## Determination 2011/018

### Determination regarding the compliance of window heads to a building at 955-957 High Street, Avalon, Hutt City

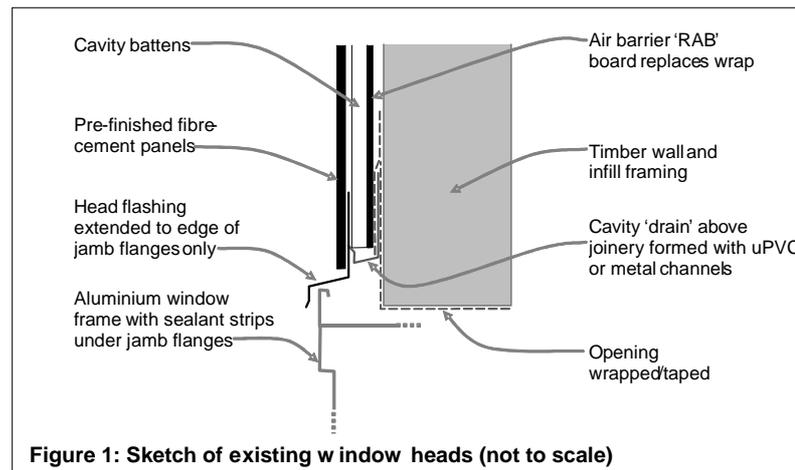
- 3.2 However, although the WANZ recommended details call for the head flashings to extend 30mm past the joinery frames, the windows were installed with the ends of the head flashings finished in line with the edge of the jamb flanges.

- junctions at jambs and sills appear weathertight
- head flashings finish in line with the jamb flanges, with no turn-ups at ends
- gaps were apparent at the ends of the head flashings
- sealant had been applied to the ends of some head flashings, although most head flashings were unsealed
- the most exposed window was on the first floor northeast wall of Bedroom 1, below the parapet (I note this was the same window that the contractor proposed to expose)
- other windows which were more sheltered under overhangs are unlikely to be regularly exposed to wind blown rain at vulnerable head to jamb junctions
- the perforated cavity closure at the bottom of the cladding allows satisfactory drainage and drying of the cavity.

- Destructive investigation and dye testing of the most exposed window confirms that the head to jamb junction has been allowing water to penetrate in the past and is still able to leak at the end of the head flashing.
- Sealant repairs to the ends of the head flashing are not effective in preventing moisture from entering the cavity in the medium to long term.
- There is no evidence of moisture penetration past the cavity into the cavity battens, RAB and wall framing.
- The cavity is currently managing any moisture that penetrates at the head to jamb junctions.

6.4 It is my view that drained cavities are intended to manage any occasional moisture ingress resulting from the failure of the primary defence mechanism. A cavity is not intended to allow for regular, or expected, water ingress. In the case of the window investigated by the expert, it is apparent that the ends of the head flashing will allow moisture to penetrate on a regular basis.

6.7 I observe that the use of the WANZ head flashing detail with the cavity closer is intended to direct any water that has entered the cavity onto the rear of the fibre-cement panels. Any defects in properly joining the cavity closer and the head flashing may allow water running down the rear face of the fibre-cement panels to be directed back into the window head. I do not consider the detail adequate for very exposed situations.

8.1 In accordance with section 188 of the Building Act 2004, I hereby determine that the window heads as installed to the exposed windows to this building (see paragraph 6.5) do not comply with Clause E2 and Clause B2 of the Building Code.
